Addendum #3
Project #2695
BC Duck Creek Highway Shop Roof Upgrades
Highway
August 27, 2024
Request for Bid

Addendum #3

1a **PARAPET FLASHING
DETAIL**

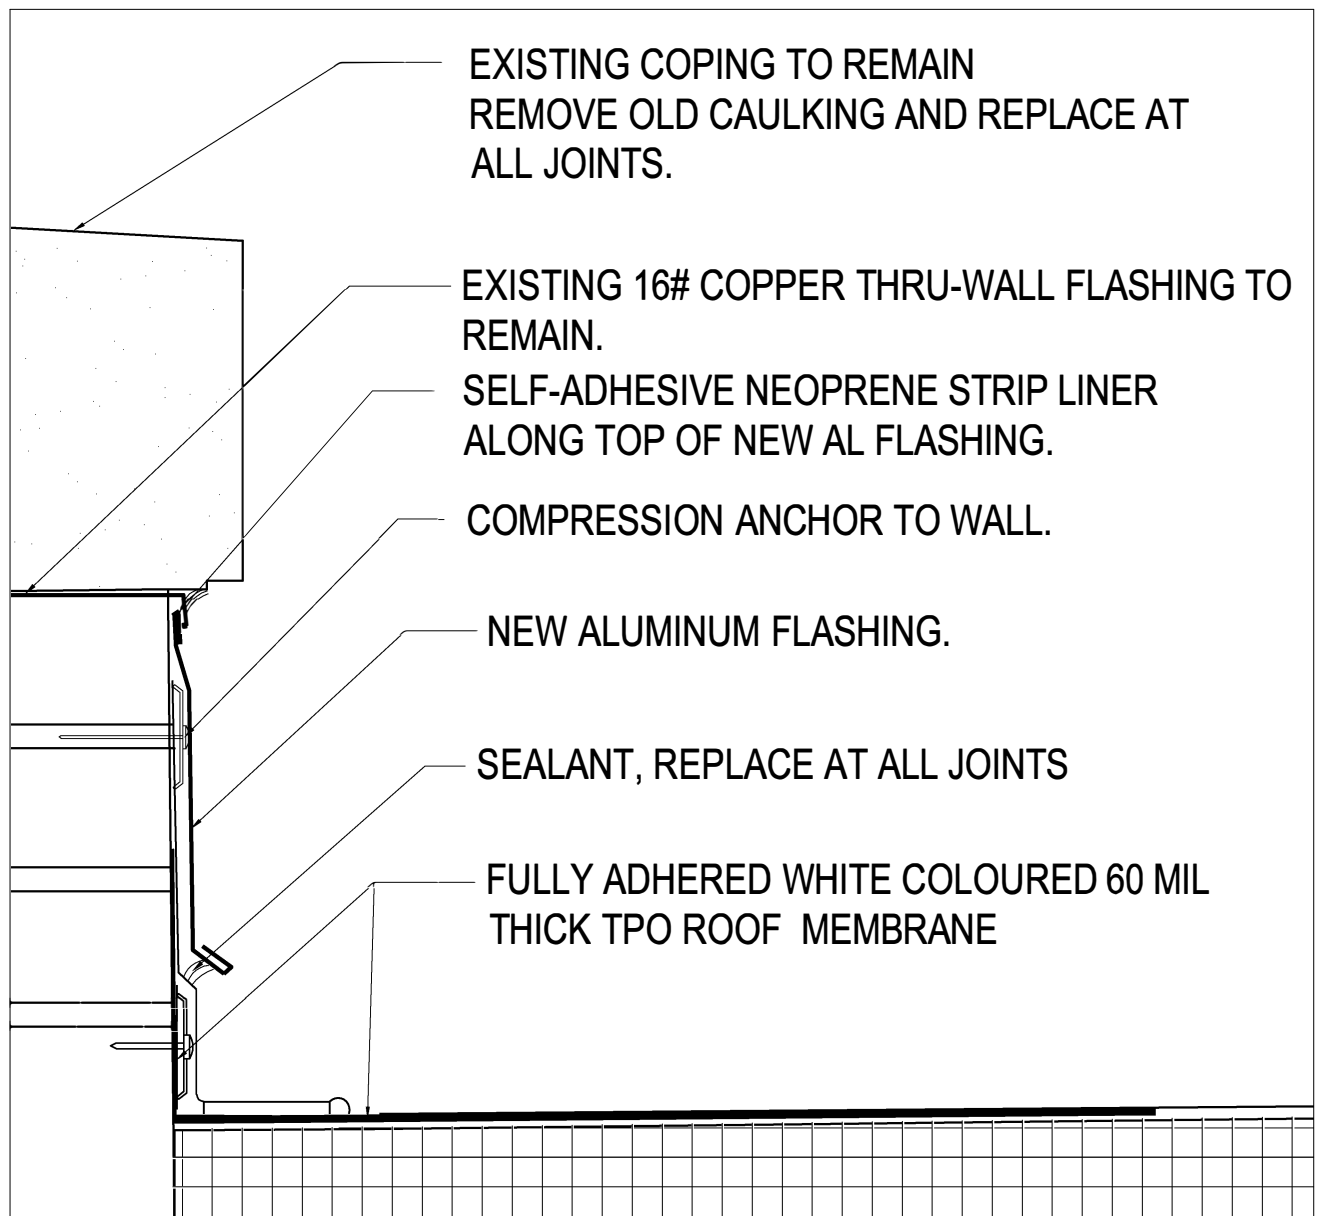
- Sheet A-202; Change keynote 9 on plan at south abandoned beam to keynote 9A. Provide new keynote 9A . “Abandoned raised beam supporting roof ladder to remain in place.”
- Sheets A-201 and A—202; Add keynote 2A, “Air Conditioning units not currently secured to rooftop to have curb provided and be secured to rooftop.”
- Sheet A-301. Detail 1; Remove term “hot-mopped” from notes, replace with “fully adhered”.
- Copper flashing to be removed from face of parapet. Copper thru-wall flashing to remain. See attached detail 1A/A301.
